City of Lawrence

TO: Planning Commission

FROM: Planning Staff

RE: **Item No. 1B: MS-18-00046:** Consider a variance from the right-of-way width and for terminating Michigan Street without a cul-de-sac for a Minor Subdivision (lot combination) for Sinclair's Addition No. 2, located at 929 Arkansas, 913, 931, 935 Michigan Street and 1000 Emery Road. Submitted by BG Consultants, on behalf of DJC Holdings LLC, Kirsten & Robin Krug, property owner of record.

Figure 1: Emery Road and Michigan Street Right-Of-Way.

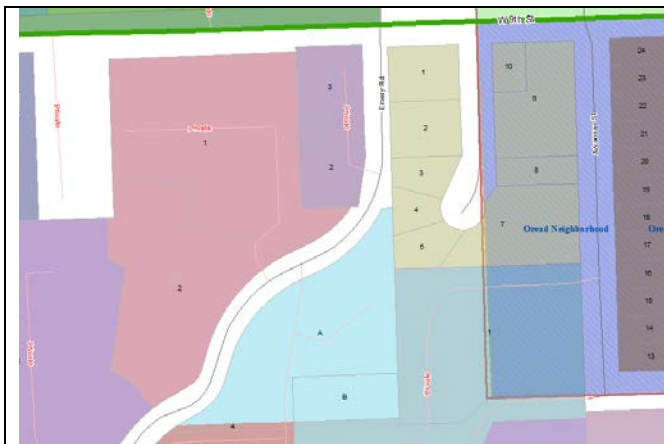
The lot located at 1000 Emery Road (proposed Lot 1, Sinclair's Addition No. 2), was platted in 1988 with only 50' of right-of-way. Emery Road existed prior to 1954. The area developed along Emery Road between the 1950's and 1990's. No additional right-of-way was acquired at that time. The development pattern along Emery Road is well established. There are no plans to widen the existing street.

The 900 block of Emery Road jogs to the east making a short section about 65' wide. The applicant proposes no additional dedication of right-of-way, keeping the ROW width at 50'. A related request, made by the applicant, is for a small vacation of a portion of Emery Road that follows the east curb line.

STAFF FINDING: Approval of the reduced right-of-way width for Emery Road is consistent with the development pattern between W. 9th Street and Sigma Nu Place. There are no other development applications proposed along Emery Road. This segment of the street is established with a high-density residential pattern.

Figure 2: Emery Road Vacation of Right-Of-Way – highlighted in purple.

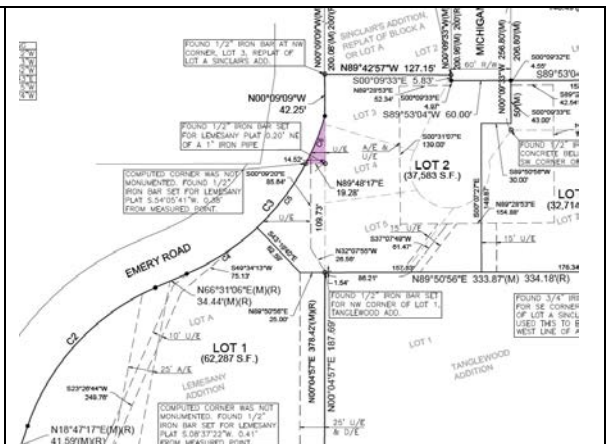
The City Engineer has reviewed the request to vacate the portion of Emery Road that is parallel to the east curb line. There are no plans to widen the road at this time. Future improvements for sidewalk could require dedication of additional pedestrian easement. The City Engineer was not opposed to the vacation of the Emery Road right-of-way.

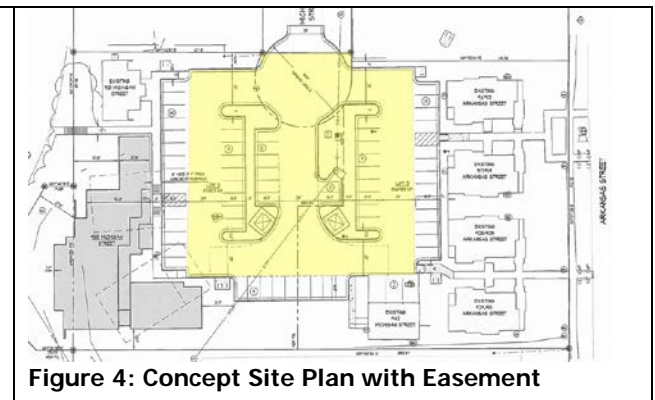
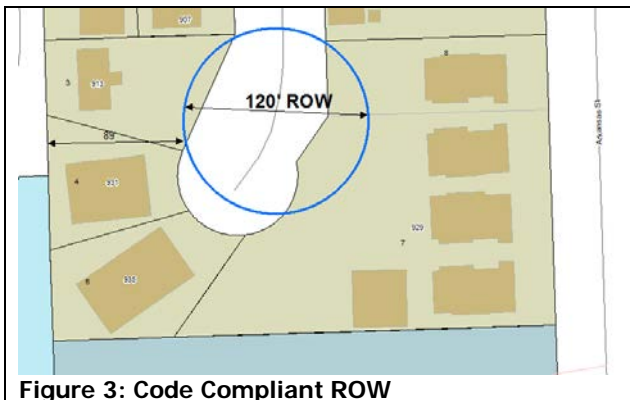
Approval of the variance to terminate Michigan Street in a code compliant cu-de-sac would reduce the area allowed to redevelop. The estimated lot depth, with a cul-de-sac, is approximate 89'. To meet minimum building setbacks for residential development (25' front yard setback, 25' rear yard setback for double frontage lots) with a 78' paved cul-de-sac the remaining lot depth is not sufficient to efficiently redevelop the property given the public improvements required (cost of construction of cul-de-sac).

Figure 5: Easement In Lieu Of ROW

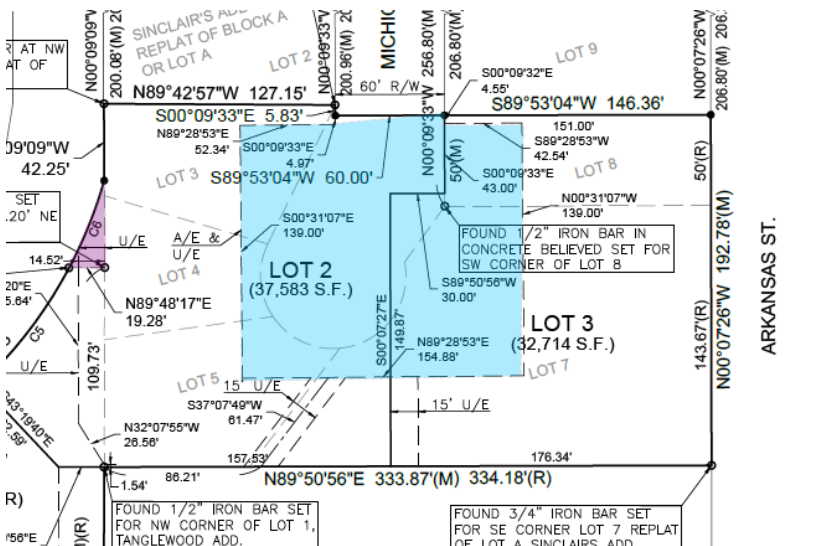
A cul-de-sac provides the ability for vehicles to access and turn around within public right-of-way and not use private property. The applicant proposes the dedication of an access and utility easement in lieu of right-of-way.

The proposed dedication of easement is larger than what would be required as right-of-way. It provides the ability for vehicle access and turnaround as needed for the safety and convenience of the public, City services and fire access.

STAFF FINDING: Granting this requested variance from the required right-of-way is not opposed to the purpose and intent of the regulations. Dedication of public access/easement to accommodate a reasonable vehicular access and turning movement is consistent with the intent to provide a subdivision that provides connectivity to the public street network and facilitates the efficient use of land.
